SERVICE BULLETIN

KODAK X-OMAT Processor

SERVICE BULLETIN NO. 201

Verify Installation of Modification No. 1 on the *Kodak X-Omat* 460 RA Processors

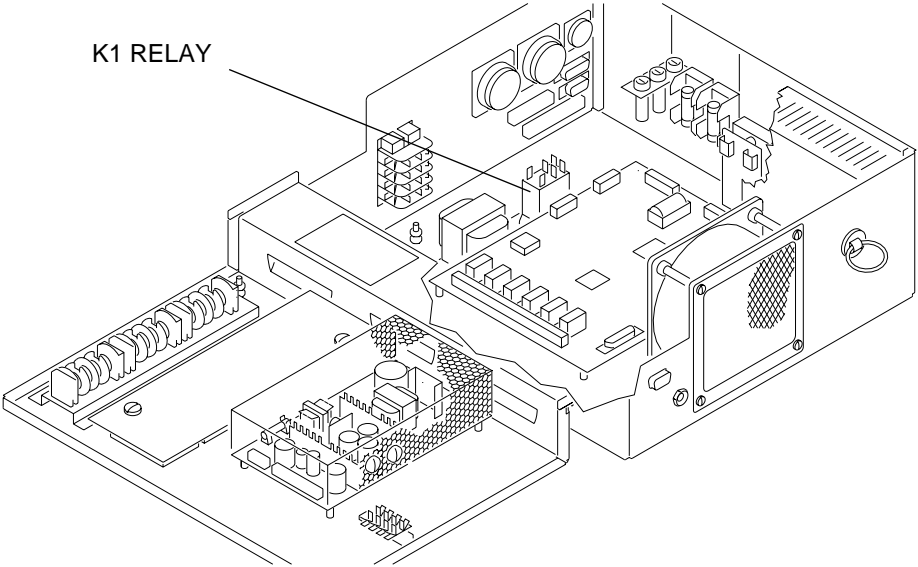
From field problem reports, it is apparent that not all 460 RAs have been updated with Modification No. 1. The purpose of this Service Bulletin is to reinforce the importance of this modification. You should verify that all 460 RAs that you service have had this modification. Modification No. 1 is Type 1, Mandatory.

Mod. No.	Part No.	Serial Nos.	Purpose	Date Available
1	MA3056-9	633 and below except for Serial No. 610, 620, 622, 624, and 628 - 631	This modification must be completed to prevent Connector P/J 502 from overheating. Overheating could cause an overcurrent and heating condition that will destroy the 500 Circuit Board and Connector. (Cable Connector Part No. 335500)	6/91
